Re: Interpretation for RZ 1998-SU-057, Timber Ridge,
Tax Map 56-2 ((1)) 6: Building Layout Modifications, Sunrooms and Bay Windows

Re: RZ 1998-SU-057
Interpretation Request-Sunrooms and Box-Bay Window

Re: RZ 1998-SU-057
Interpretation Request – Sunrooms and Box-Bay Window

OPTION TO PROVIDE SUNROOM A

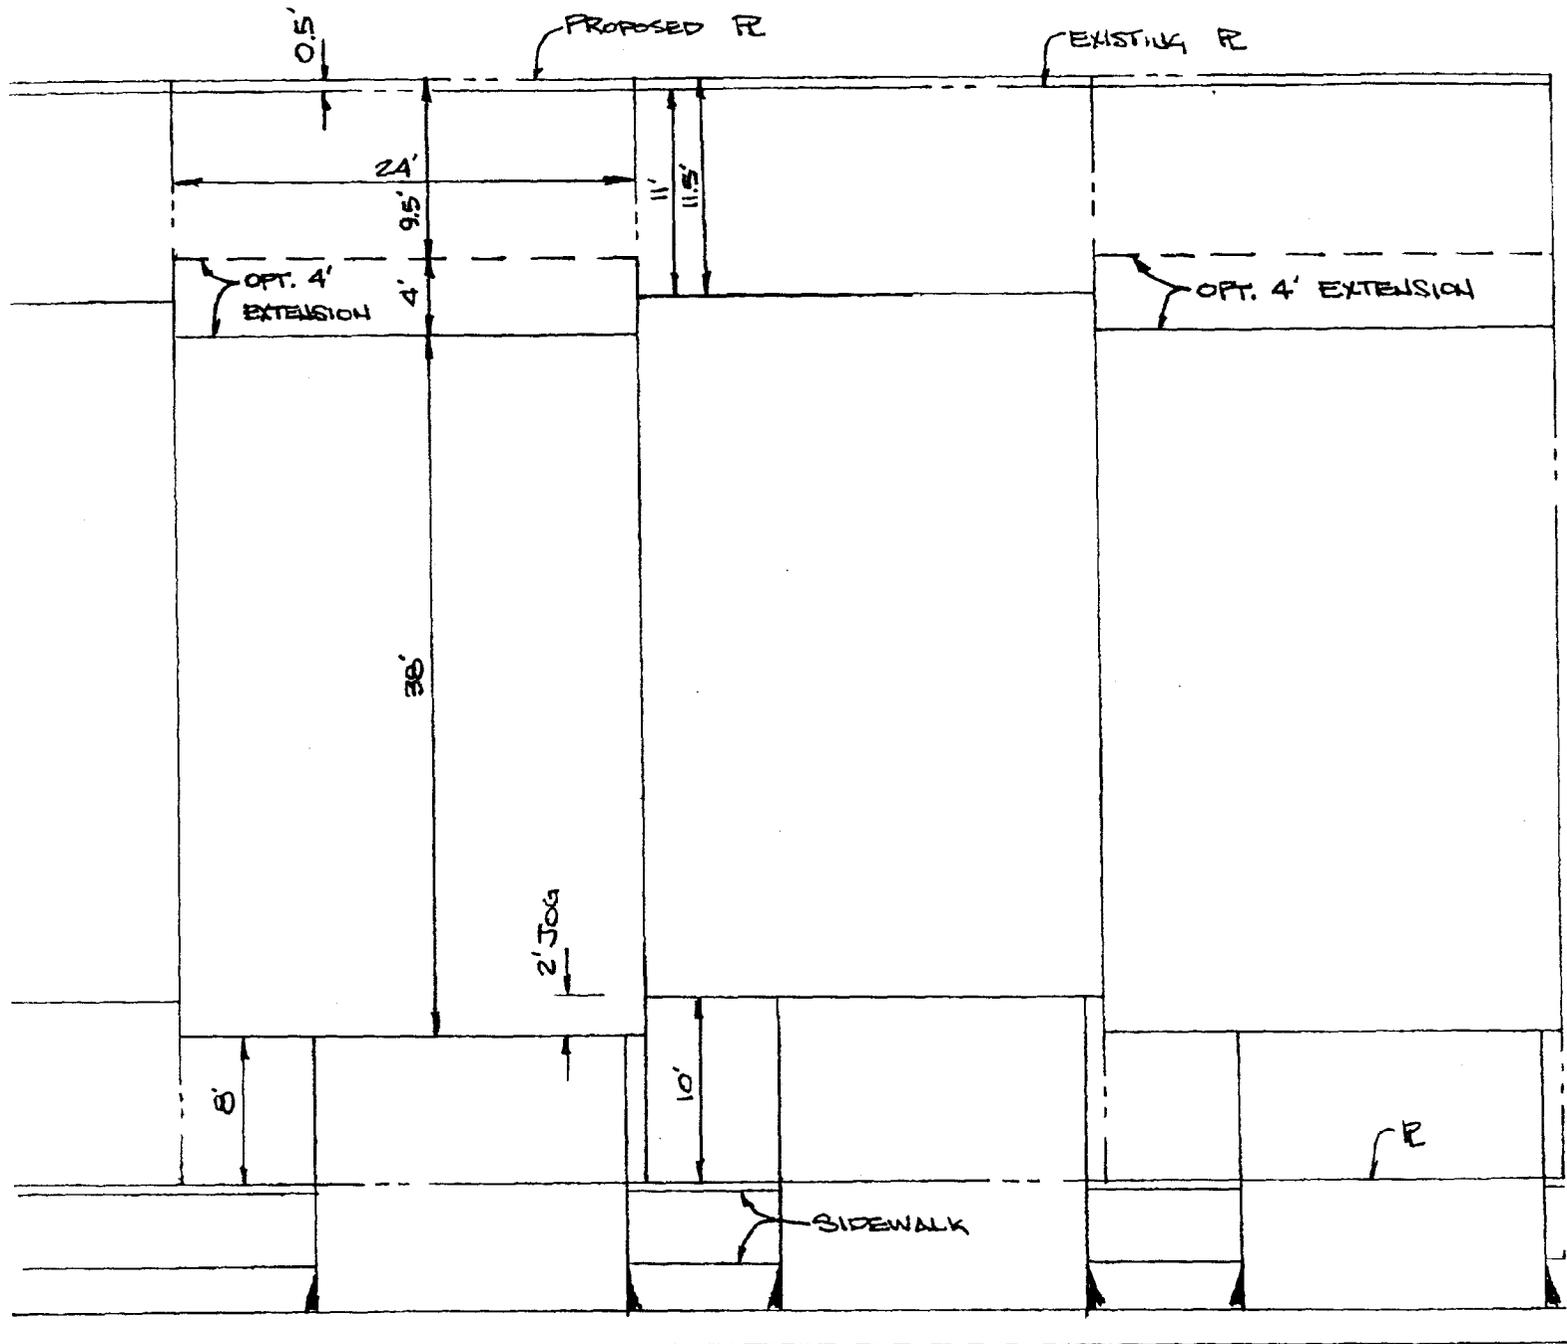
As I understand it, your first question is whether the addition of sunrooms on the back of the townhouse units would be in substantial conformance with the proffers and Conceptual/Final Development Plan (CDP/FDP). In this option, you are proposing to extend the townhouse lots by six (6) inches to the rear of the units in order to provide the sunroom option while maintaining the required 200 square foot privacy yards. However, this proposal would reduce the rear yard setbacks of the units from 11 feet as shown on the CDP/FDP, to 5.5 feet. It is my determination that this proposed sunroom addition option is not in substantial conformance with the CDP/FDP.

- Alternative 1 – The rear property line will be extended by six (6) inches, which will allow for the maintenance of the two-hundred (200) square foot rear privacy yard and the eight foot front yard. This will allow for the construction of Optional Sunroom A.

OPTION TO PROVIDE 4' EXTENSION

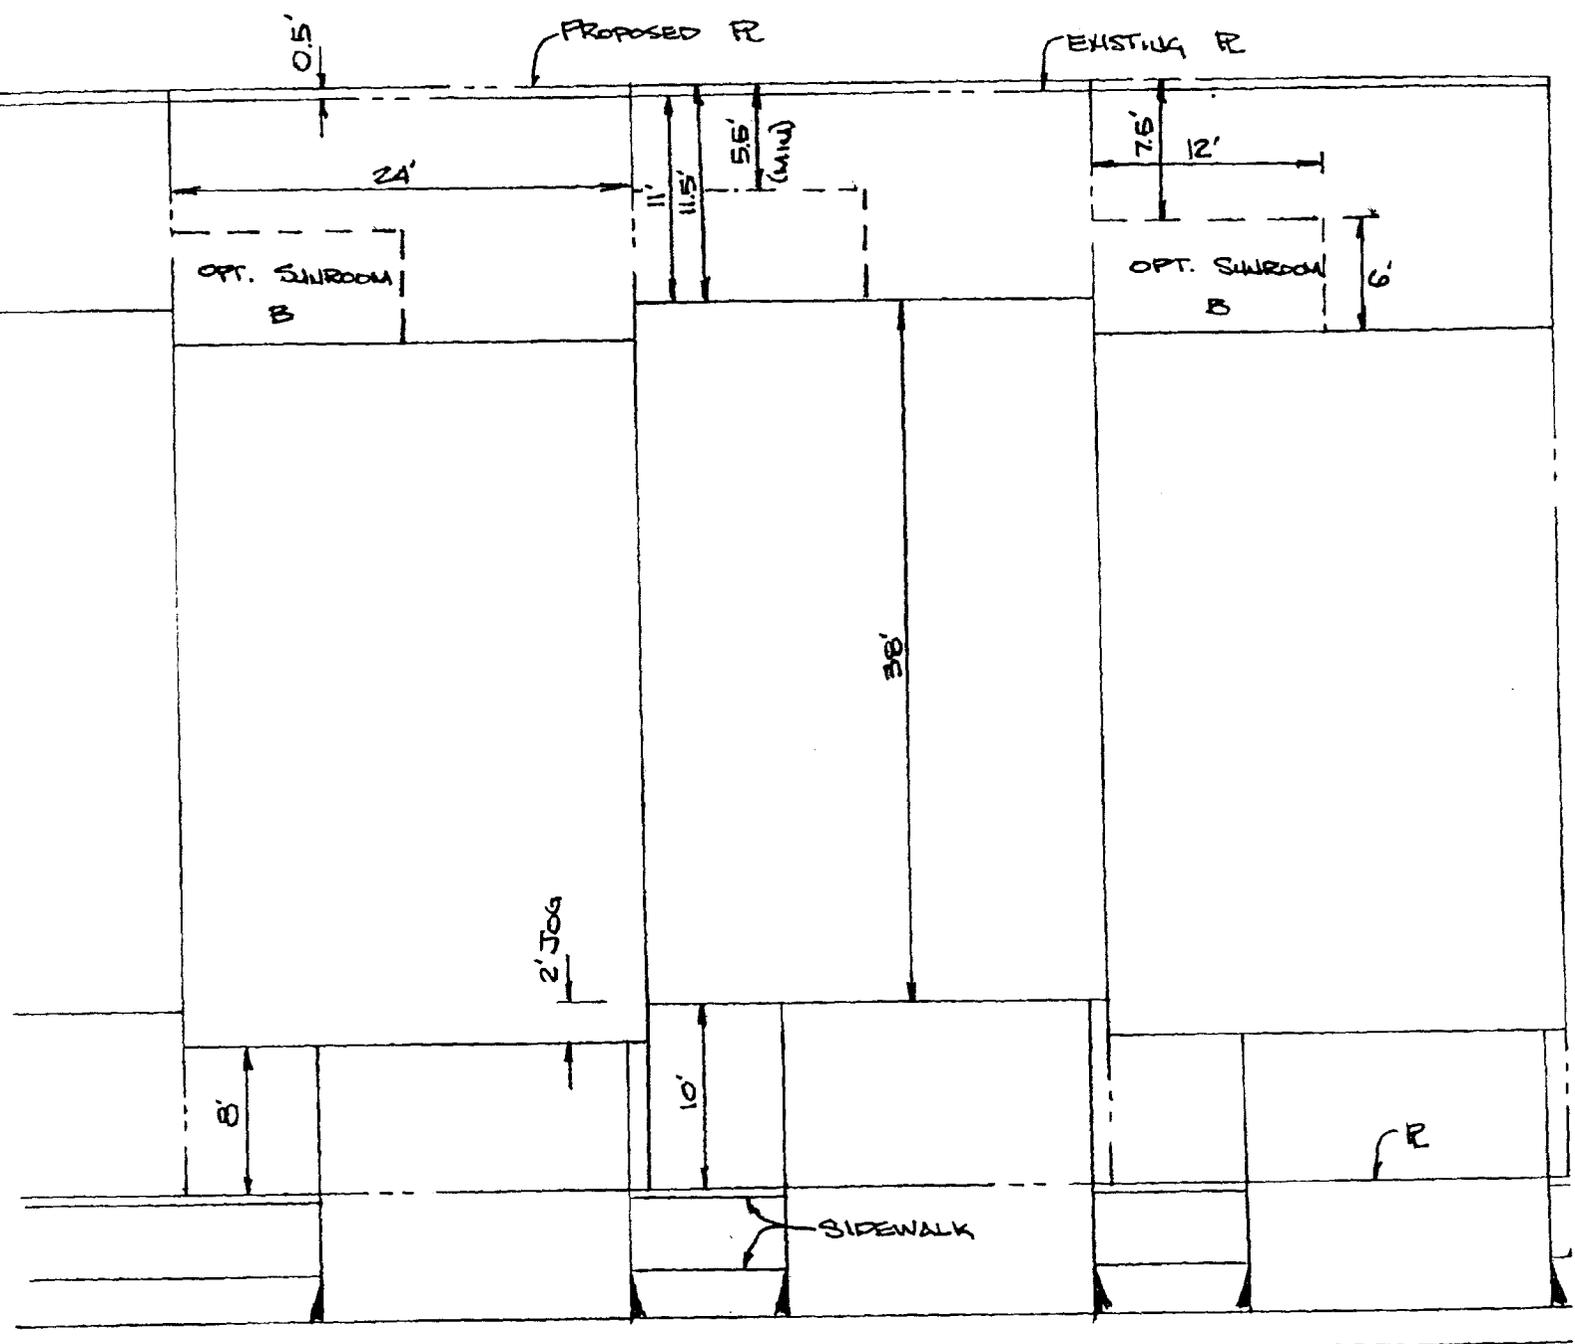
Your second question is whether an option that extends the units by 4 feet to the rear would be in substantial conformance with the CDP/FDP. You are proposing to maintain the front yard setbacks, however the rear yard setbacks of 11 feet as shown on the CDP/FDP are reduced to 8 feet. It is my determination that extending the units 4 feet to the rear is not in substantial conformance with the CDP/FDP.

- Alternative 2 - The rear property line will be extended by six (6) inches, which will allow for the maintenance of the two-hundred (200) square foot rear privacy yard and the eight foot front yard. This will allow for the construction of an optional four (4) foot extension to the rear of each unit.

OPTION TO PROVIDE SUNROOM B

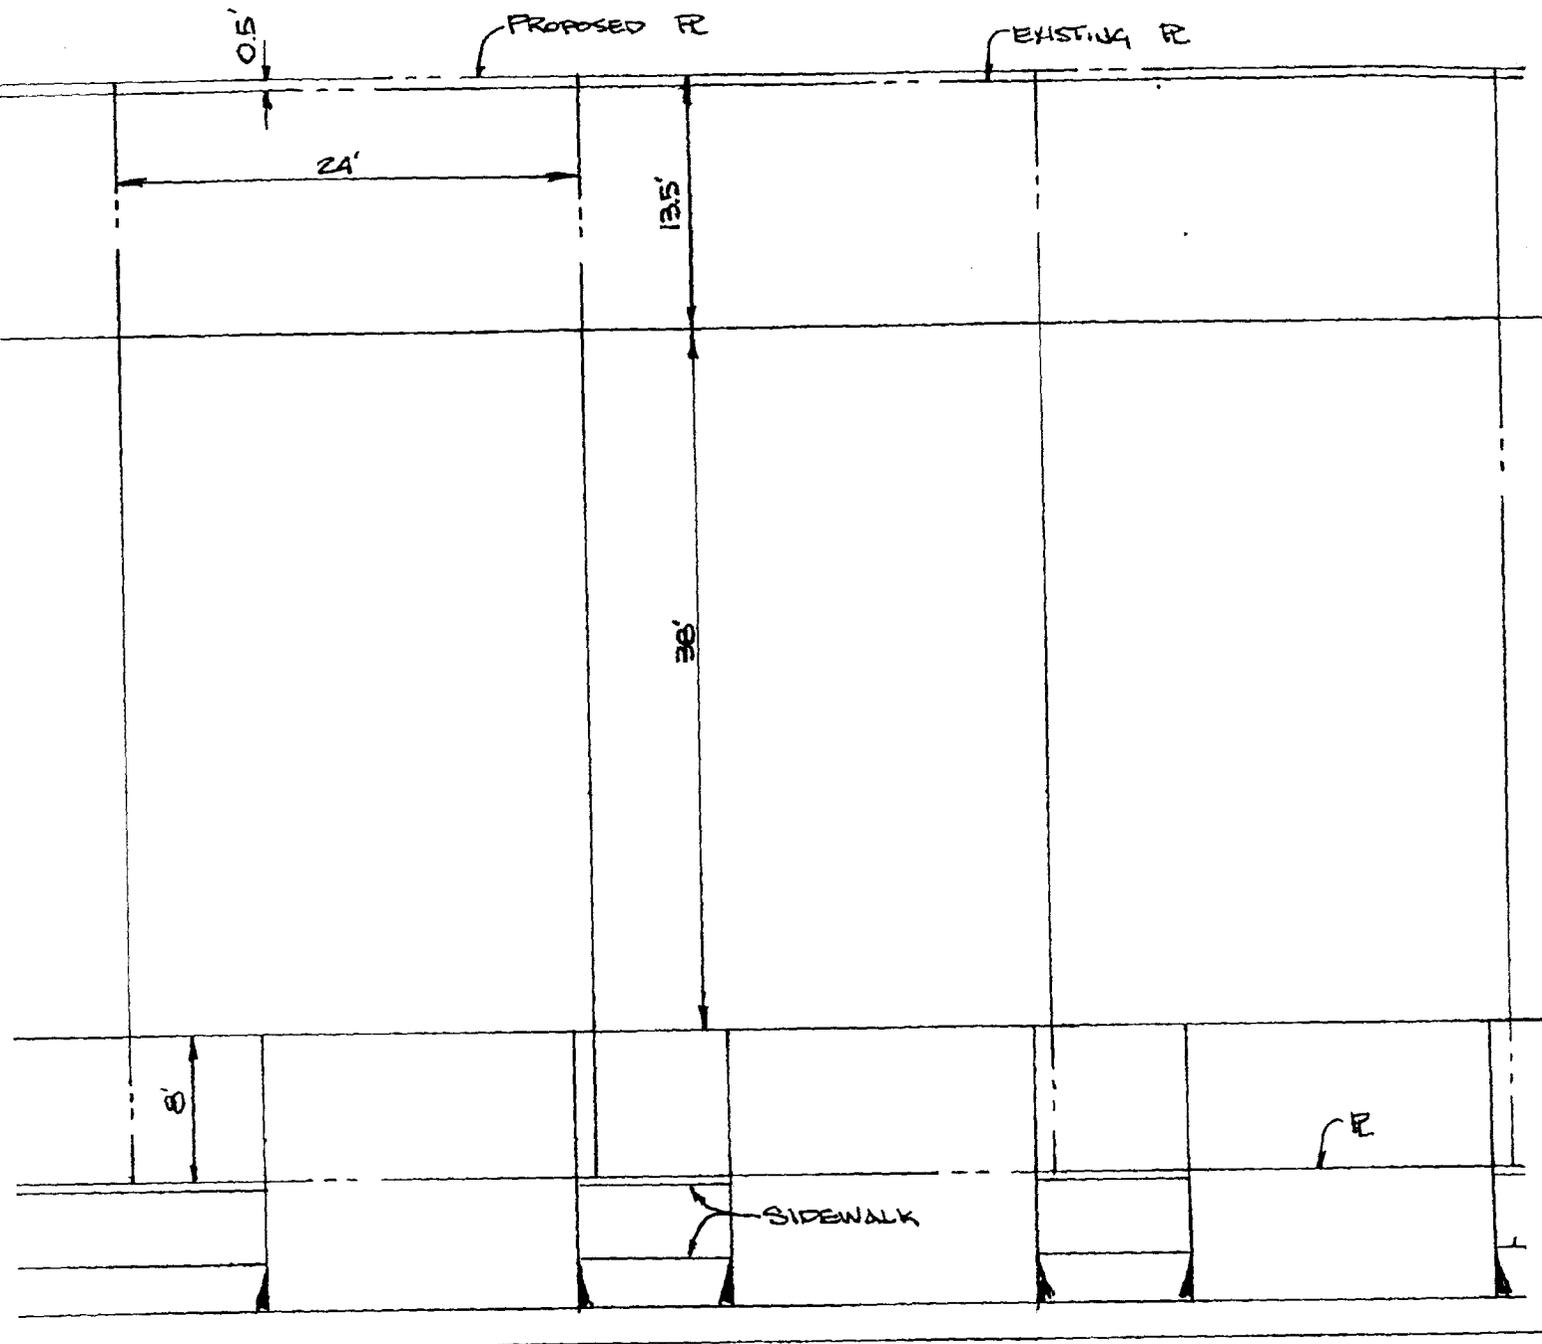
- Alternative 3 - The rear property line will be extended by six (6) inches, which will allow for the maintenance of the two-hundred (200) square foot rear privacy yard and the eight foot front yard. This will allow for the construction of Optional Sunroom B.

OPTION TO PROVIDE FLUSH UNITS (NO OFFSET JOGS)

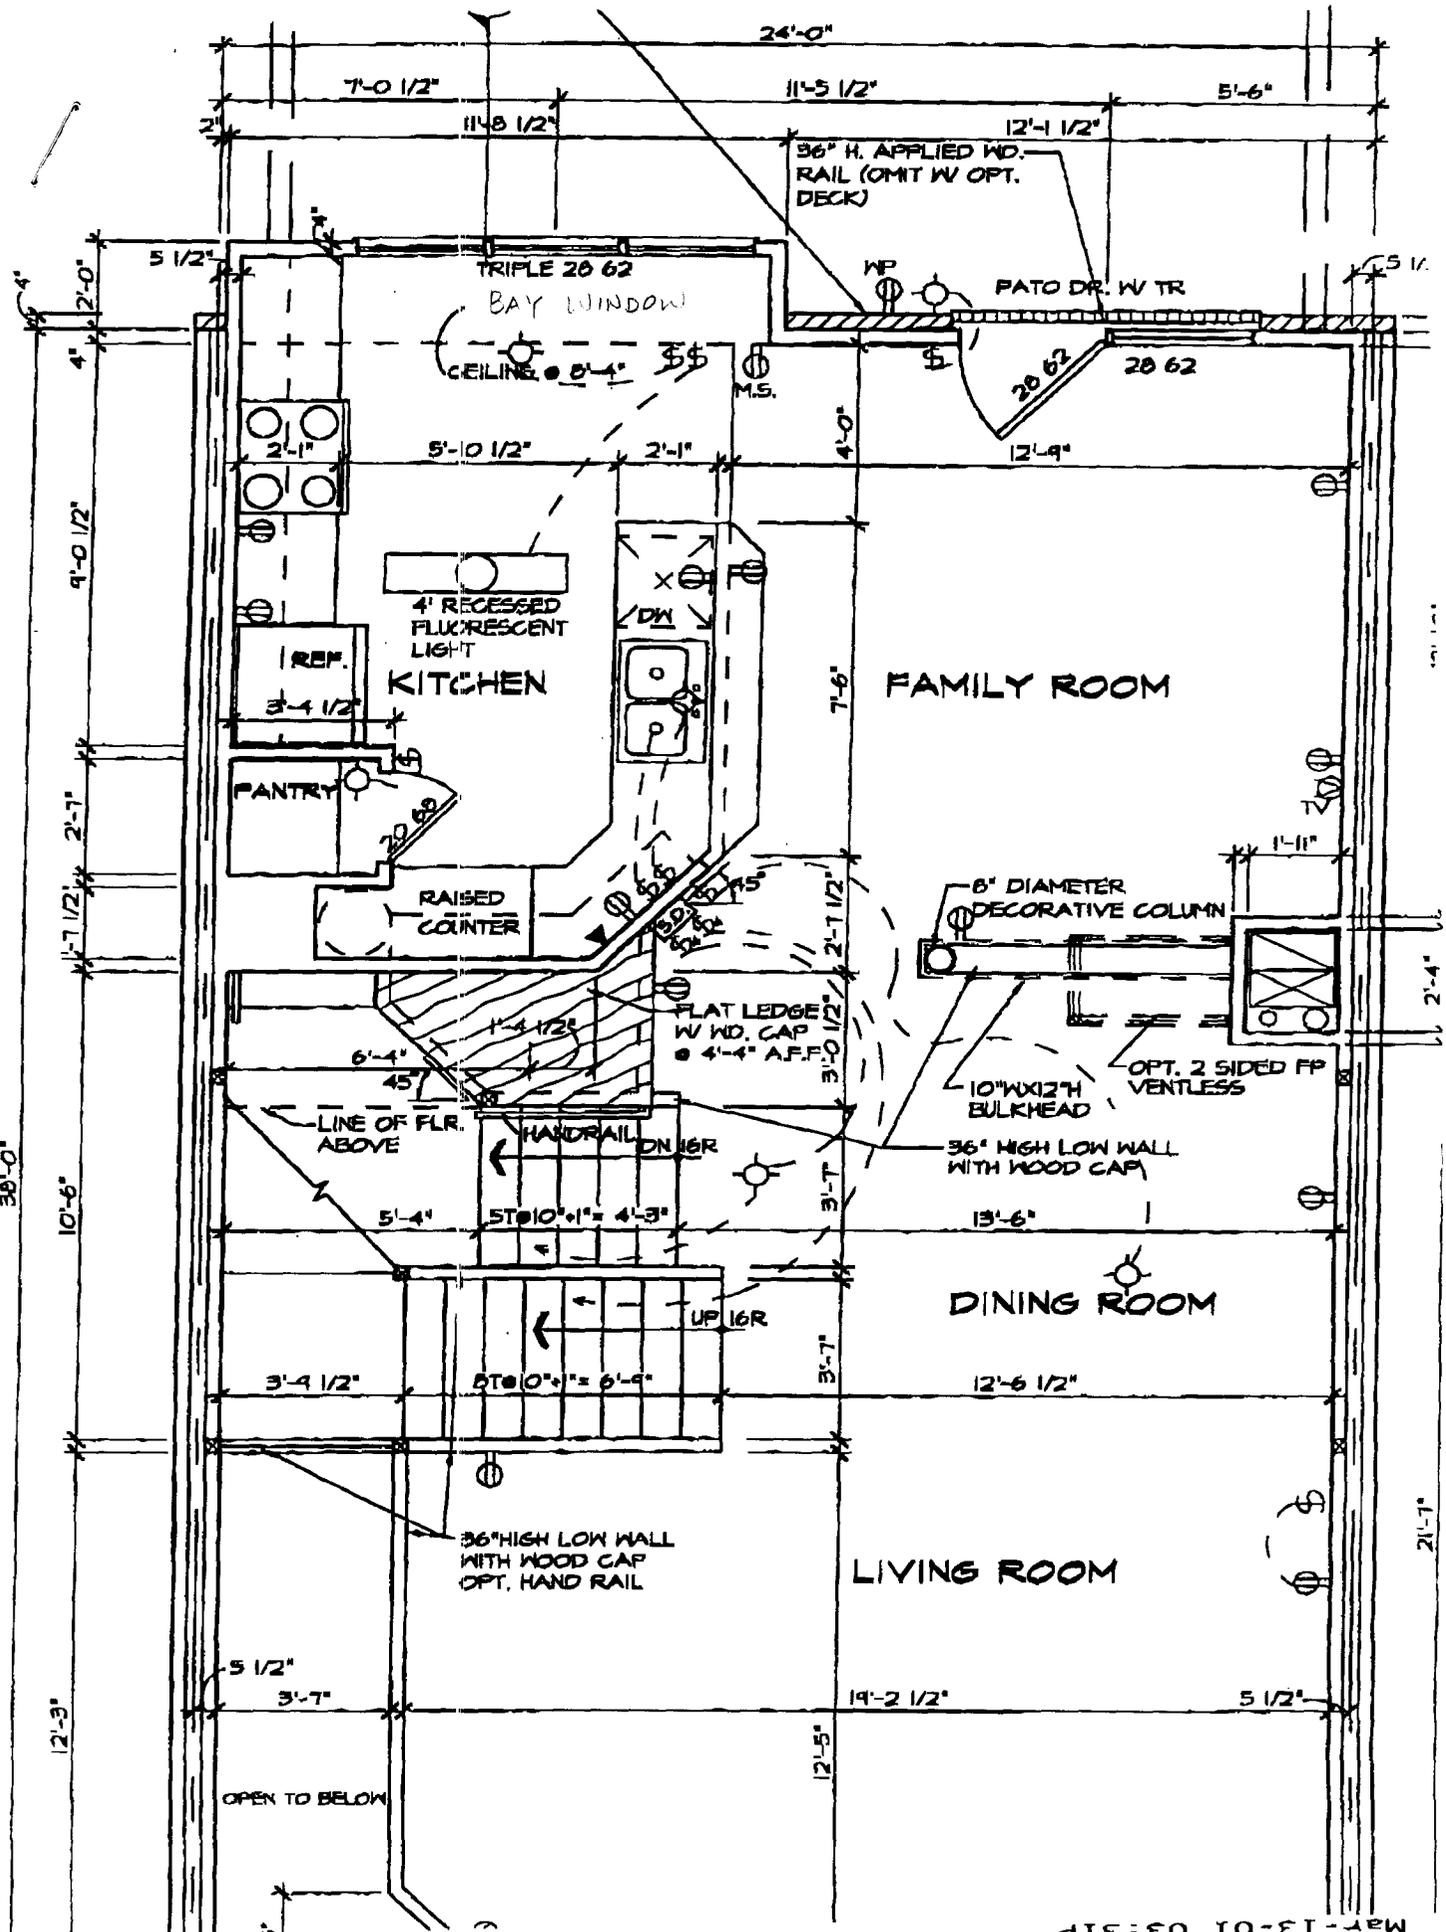
Your third question is whether the alignment of front of all units in a straight line, eliminating the staggered setbacks would be in substantial conformance with the approved CDP/FDP. The typical

layout of townhouse units shown on the CDP/FDP shows a staggered arrangement of units. It is my determination that your proposal to align all units in a straight line, eliminating the staggered arrangement is not in substantial conformance with the CDP/FDP and would be, in most if not in all instances, in violation of the provisions of Article 20 of the Zoning Ordinance.

- Alternative 4 - The rear property line will be extended by six (6) inches, which will allow for the maintenance of the two-hundred (200) square foot rear privacy yard and the eight foot front yard. The units have also been adjusted so that all fronts of the units are aligned. This would allow for an extension at the rear of the units.
